Re:	PC #:	B1103915
	Commercial Plan Review Dated:	8.17.11
	Project Name:	Chase – CPC Alton
	Address:	1801 Alton Road
	Occupancy:	B

(Revision 3, PLAN REVIEW COMMENTS, dated 04-22-2013)

JPM CHASE - Alton Road
CPC Interior Renovations
1801 Alton Road
Miami Beach, FloridaEXIT 2
3'-0"
(34" CLEAR)0 4' 8' 16'
SCALE: 1/8" = 1'-0"AREA OF
WORK
FURNITURE
ONLYAREA OF
WORKEXIT 2
6'-0"
(68" CLEAR)AREA OF
WORK

A1.2

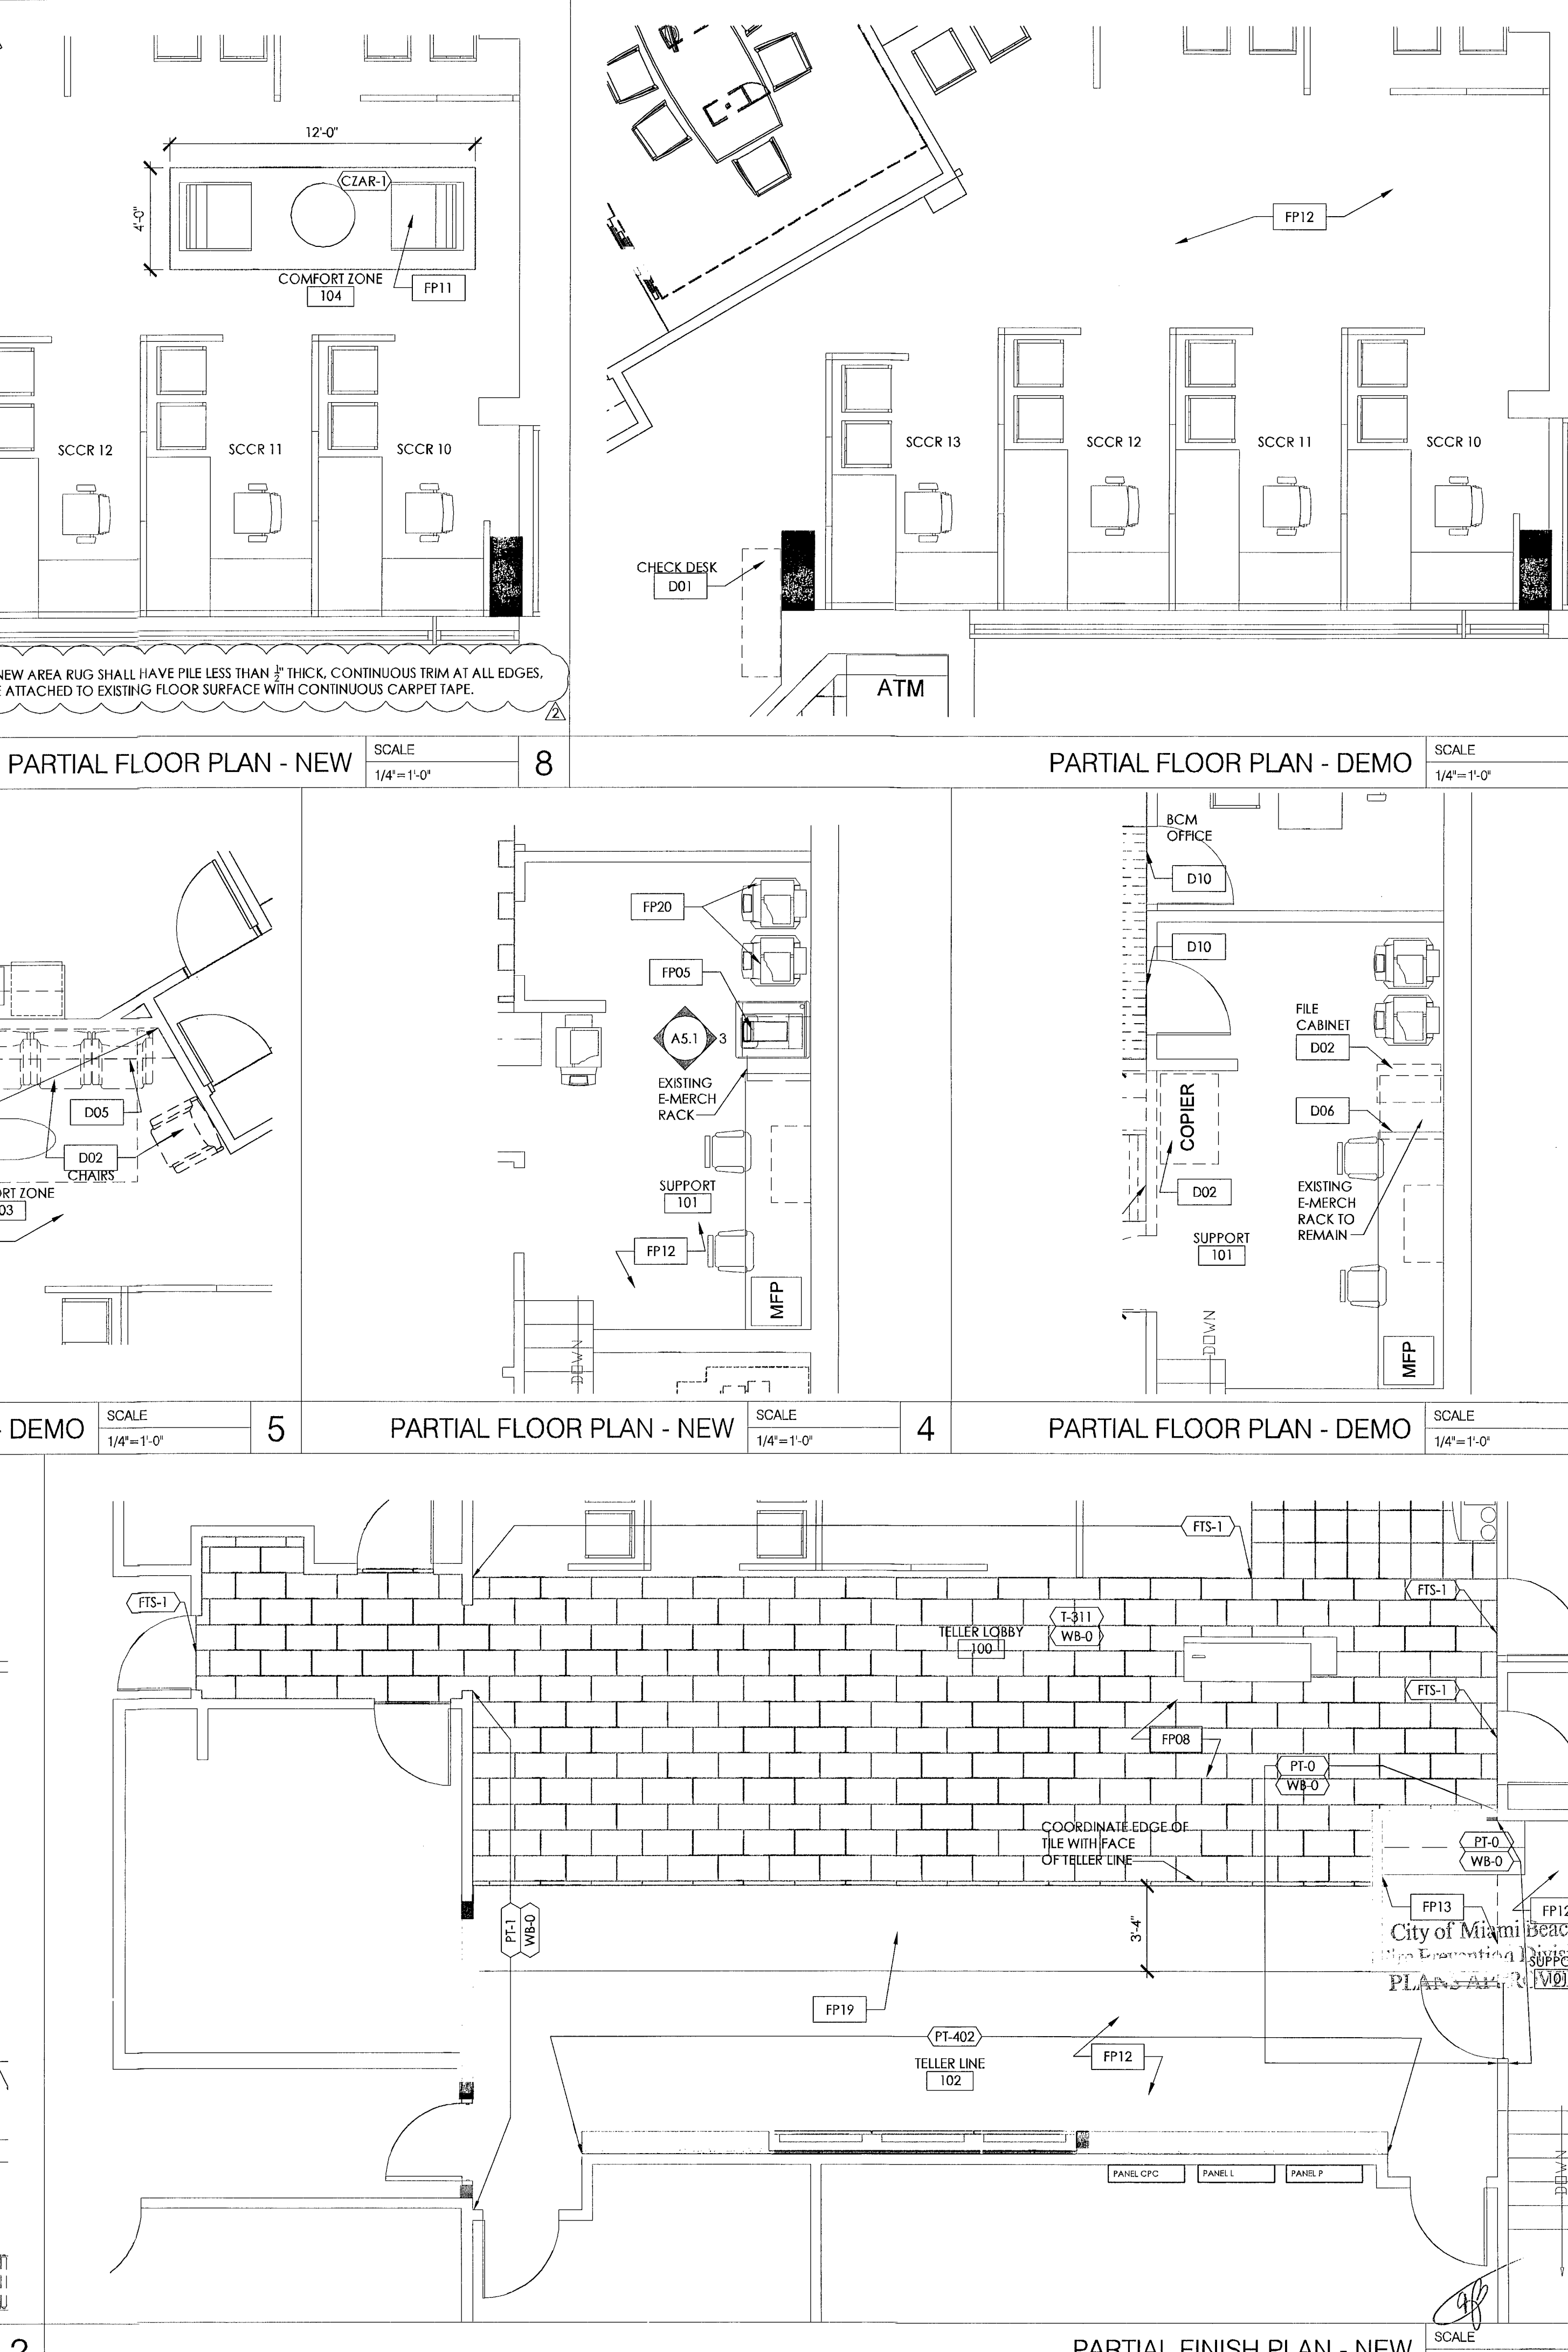
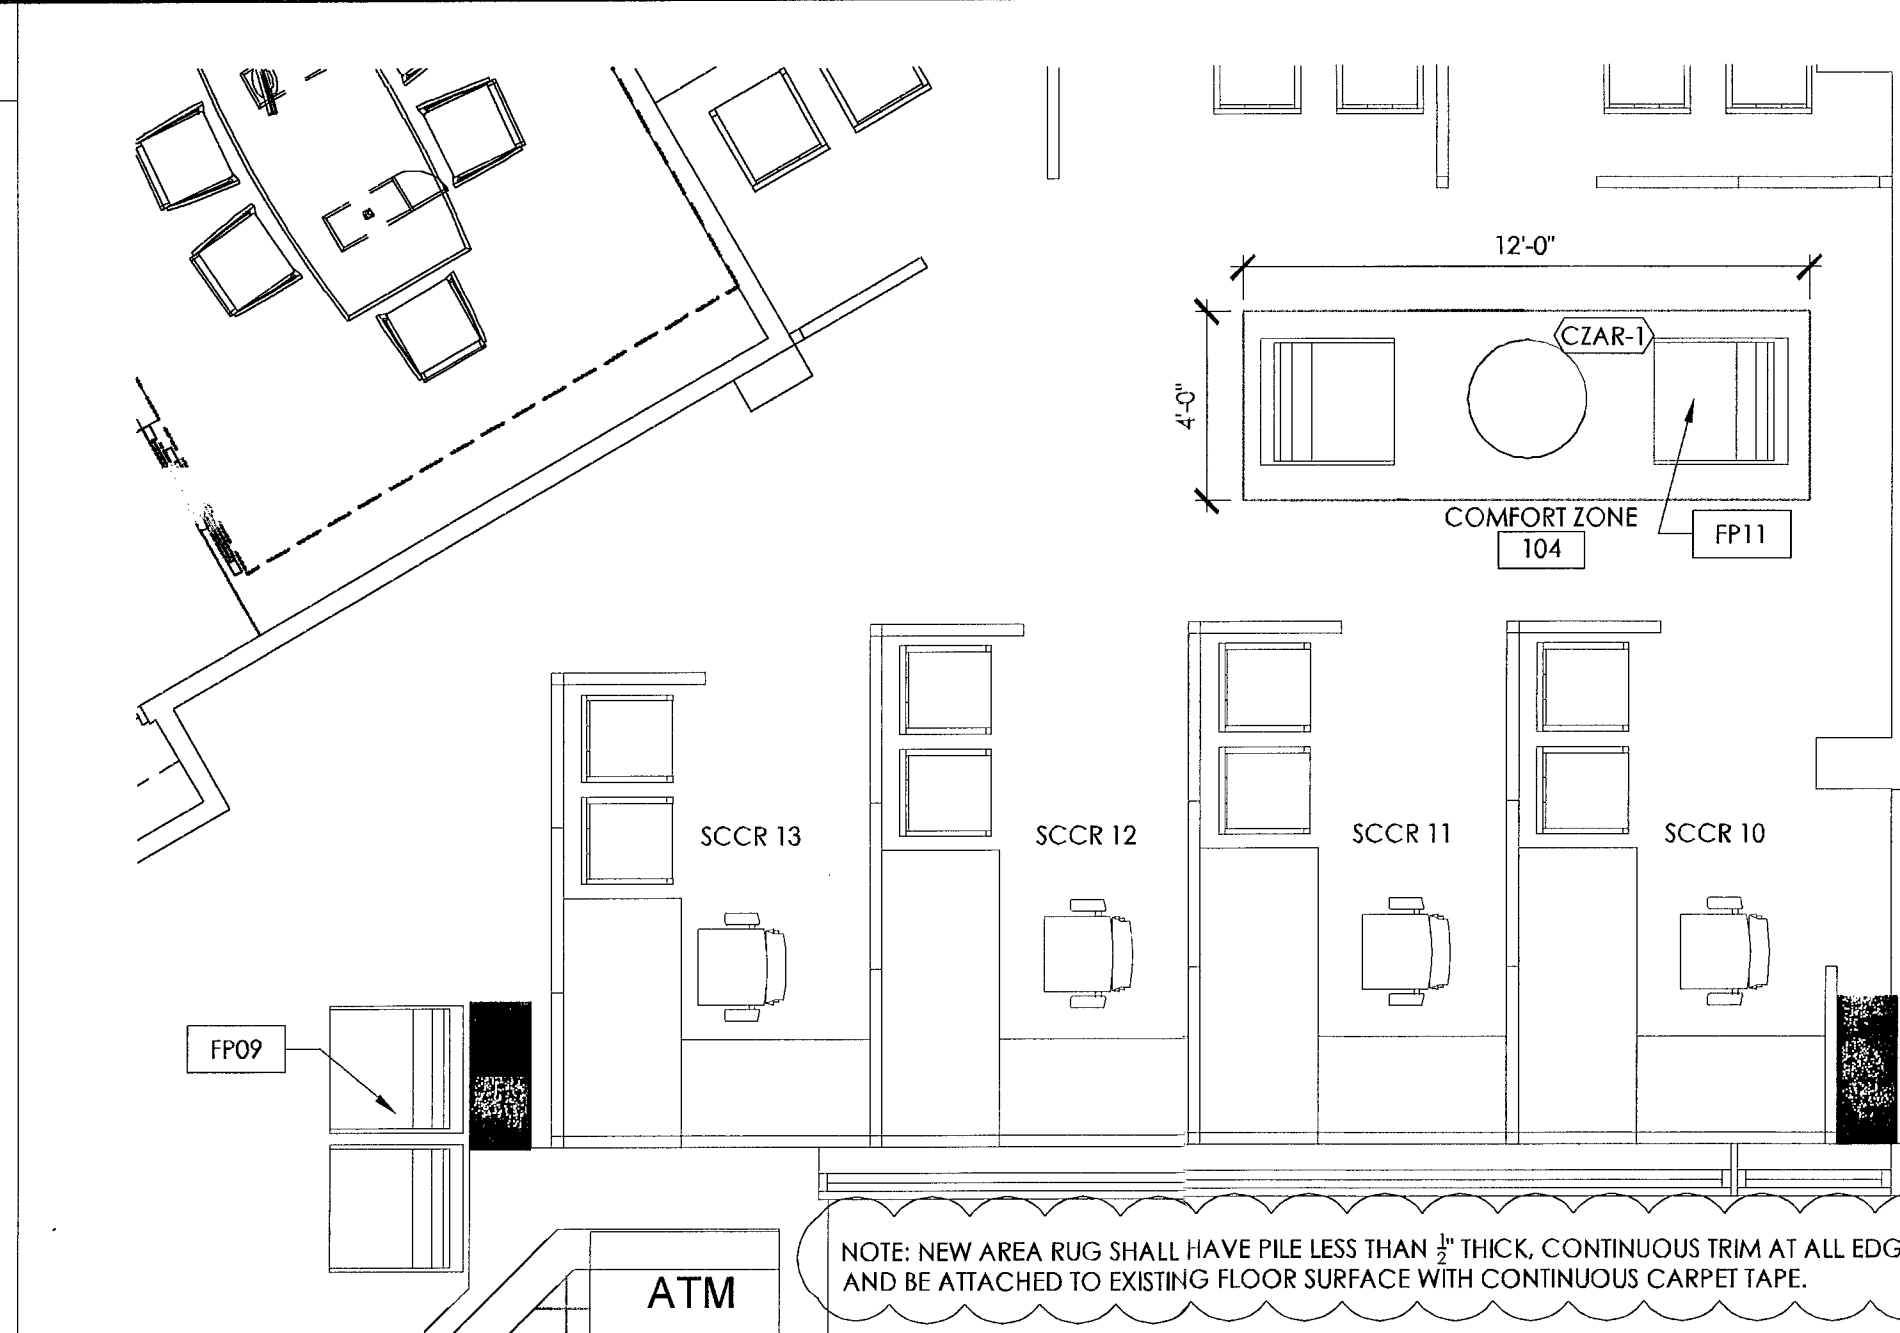
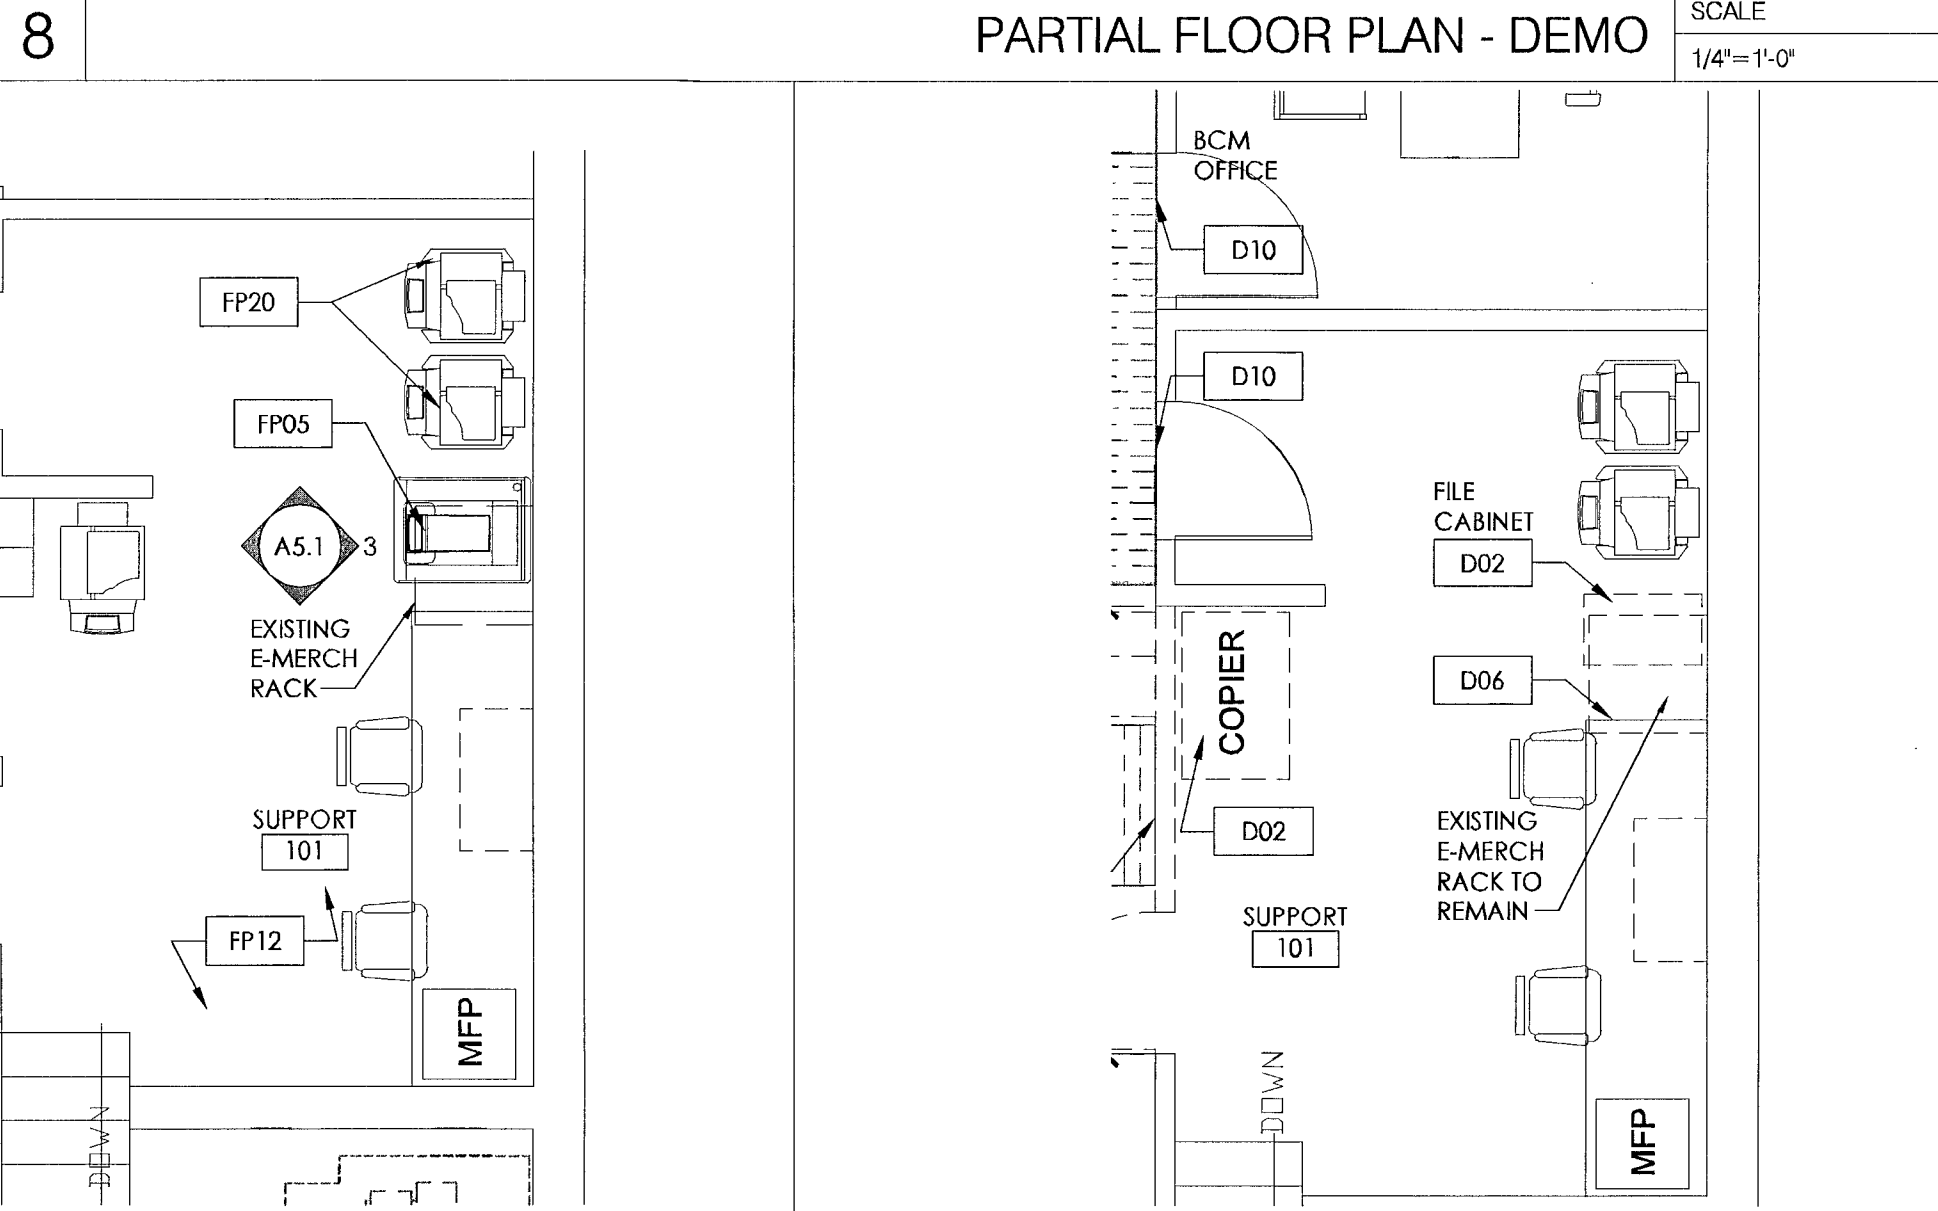
6. **Sheet A1.2: Comfort zones: Provide 36" accessible furniture clearance and provide carpet requirements to comply with FAC §302.2.**

7. **Plan 2/A1.2: Check desk FP09: Provide check writing desk accessible details to comply with FAC §904.3.3.**

RESPONSE: Please refer to attached revised sheets A0.0 & A1.2 for accessible clearance and carpet requirements.

RESPONSE: Please refer to attached revised sheet A5.1, detail 9, for accessibility assessment of existing check desk to be relocated.

SECTION AT MEDIA WALL

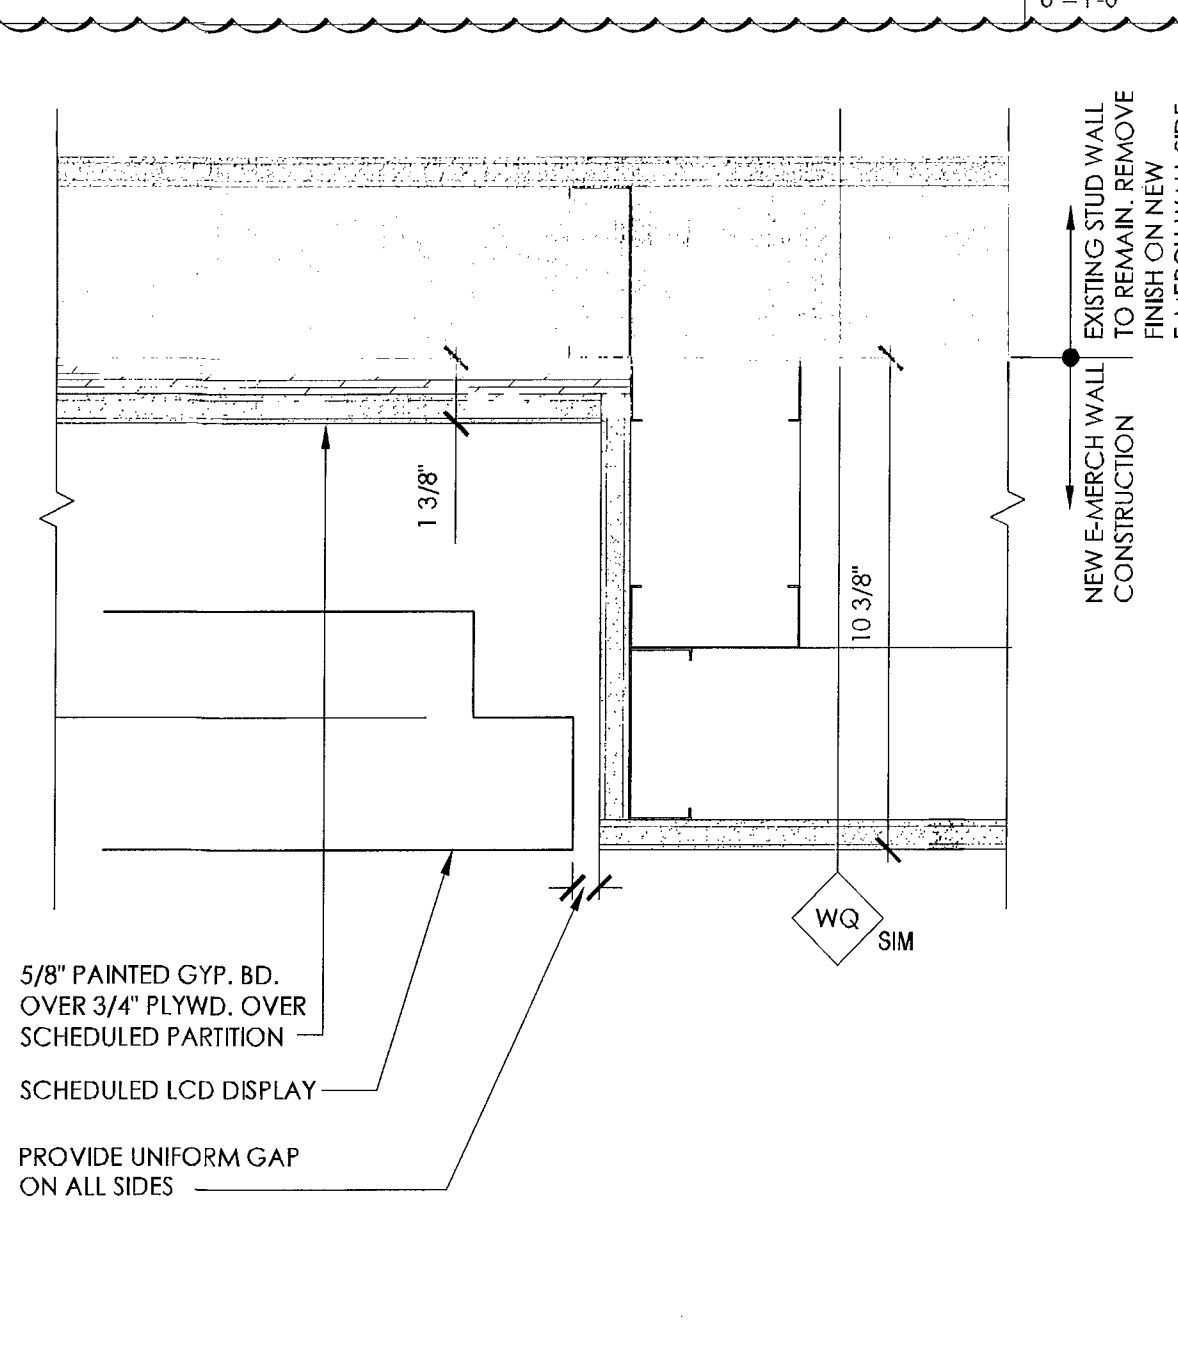
10. **Section 5/A5.1: Provide bottom of counter knee clearance dimension, 27" minimum, per FAC §306.3.**

11. Section 5/A5.1: Provide 25" maximum reach dimension, suggest reduce 1'-9" dimension to 1'-1" to comply with FAC §308.2.

RESPONSE: Please refer to attached revised sheet A5.1, detail 5, for requested information.
